Service Bulletin

American Honda Motor Co., Inc.

2001-2004 GL1800/A Trunk Opener Unit

PART DESCRIPTION

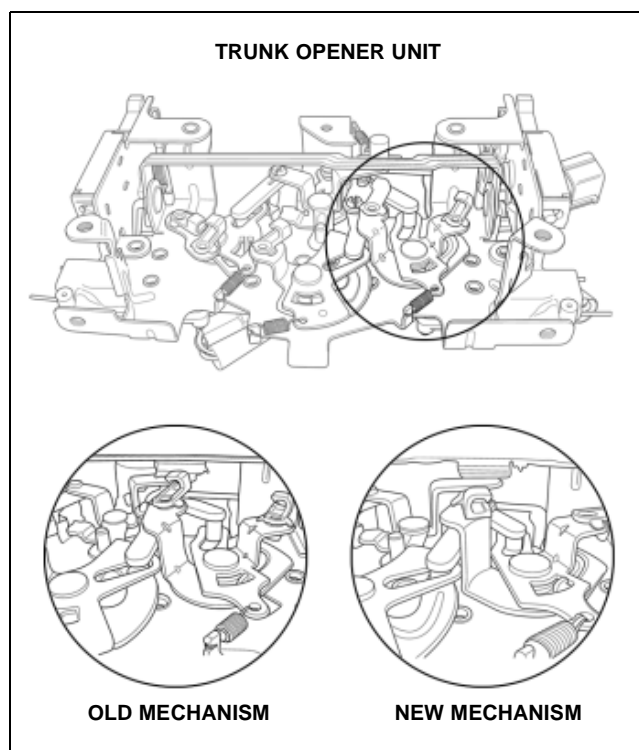
Some customers may experience trunk or saddlebag lids not opening when the corresponding latch lever is pulled.

To correct this condition, the opener mechanism must be replaced with a new opener mechanism.

Opener Unit
P/N: 81310-MCA-A22
H/C: 7700768
